From: Habib, Donald
Sent: Friday, July 17, 2015 2:02 PM
To: PMLevyCOLPEm Resource
Attachments: Reviewers Aid APP-GW-GLR-607 Revision 3 Final reduced size.pdf

Tier 1 Changes

Tier 2 Changes

Figure 6.3-21
Passive Core Cooling System
Piping and Instrumentation Diagram (Sheet 2 of 3)

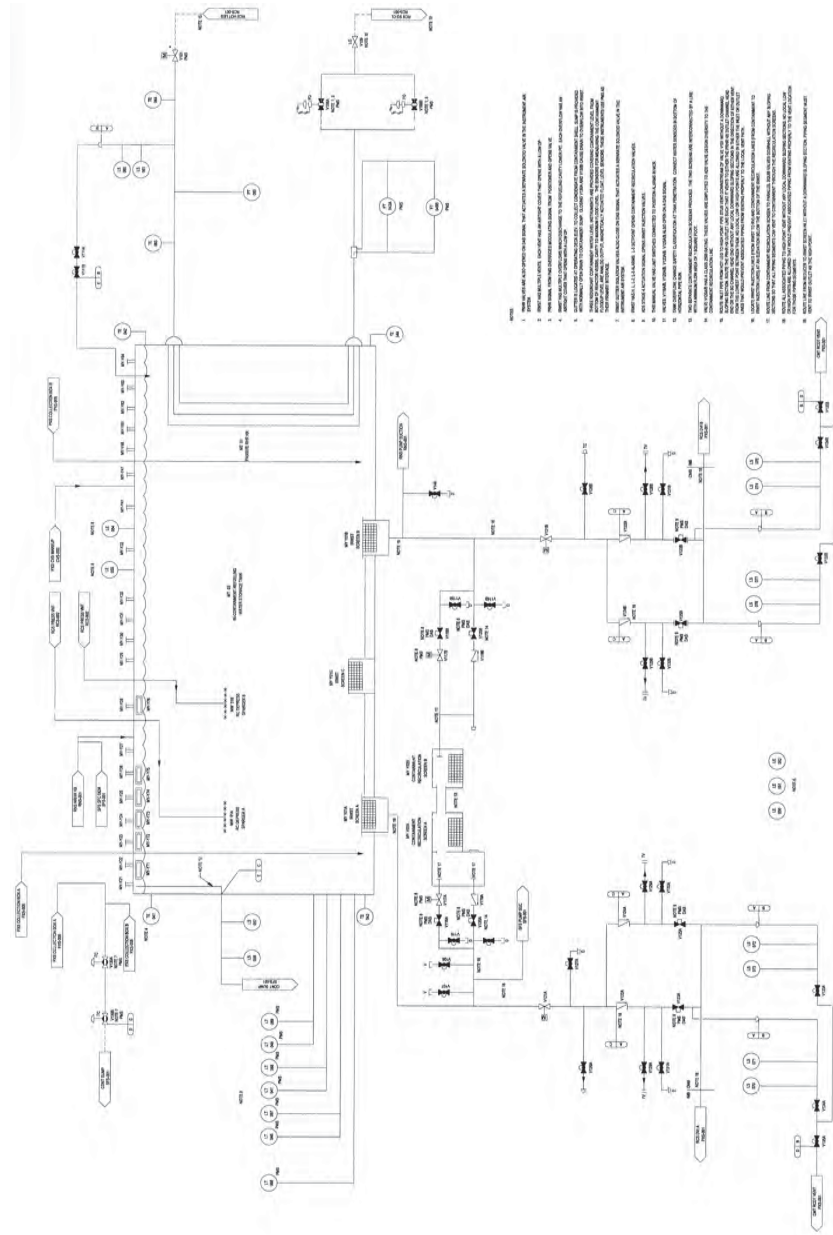
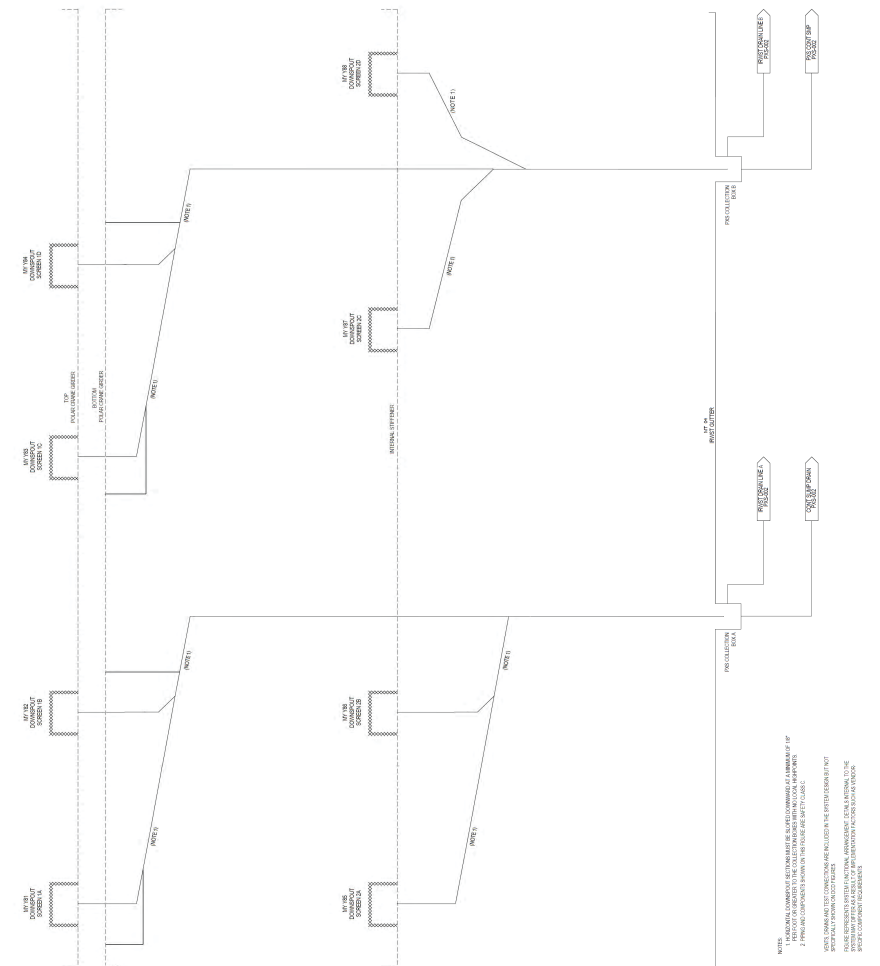
Figure 6.3-2 not used.
(Renumbered as Figure 6.3-1, Sheet 2)

Figure 19E.4.10-1

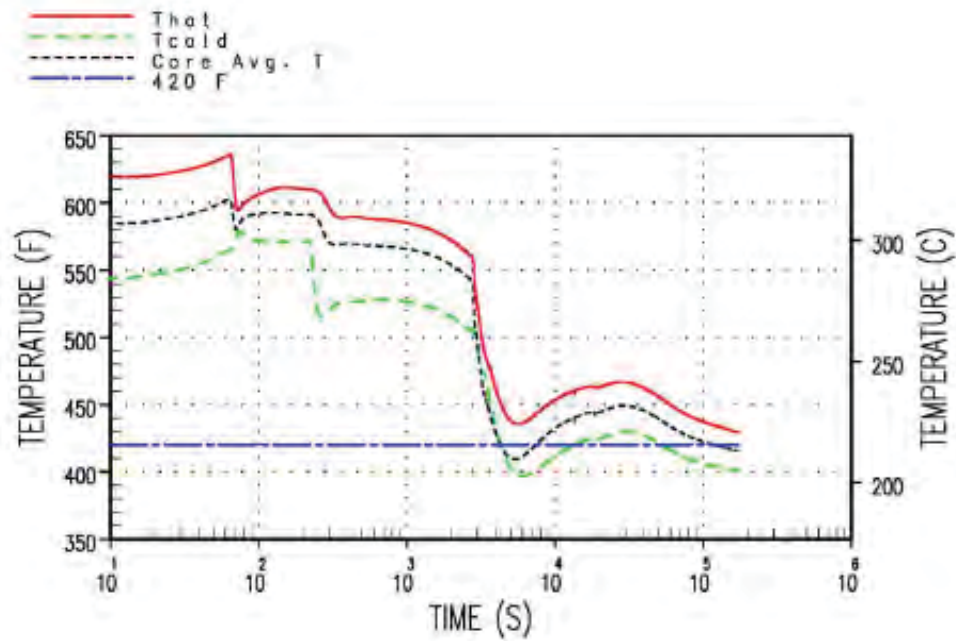
Once actuated, at about ~~2,700~~4600 seconds, the CMTs operate in recirculation mode, injecting cold borated water into the RCS. In the first part of their operation, due to the ~~injection of cold water~~flow rate, the CMTs operate in conjunction with the PRHR ~~HX~~ to reduce RCS temperature. Due to the primary system cooldown, the PRHR heat transfer capability drops below the decay heat and the RCS cooldown is essentially driven by the CMT cold injection flow. However, at about ~~3,565~~6,000 seconds, the CMT cooling effect decreases and the RCS starts heating up again (Figure 19.E.4.10-1). The RCS temperature increases until the PRHR HX can match decay heat. At about ~~31,000~~ 46,700 seconds, the PRHR heat transfer matches decay heat and it continues to operate to reduce the RCS temperature to below 420°F within 36 hours. As seen from Figure 19E.4.10-1, the cold leg temperature in the loop with the PRHR is reduced to 420°F ~~at 82,600~~ 52,900 seconds, while the core average temperature reaches 420°F ~~within 123,600~~ 120,900 seconds (approximately 34 hours).
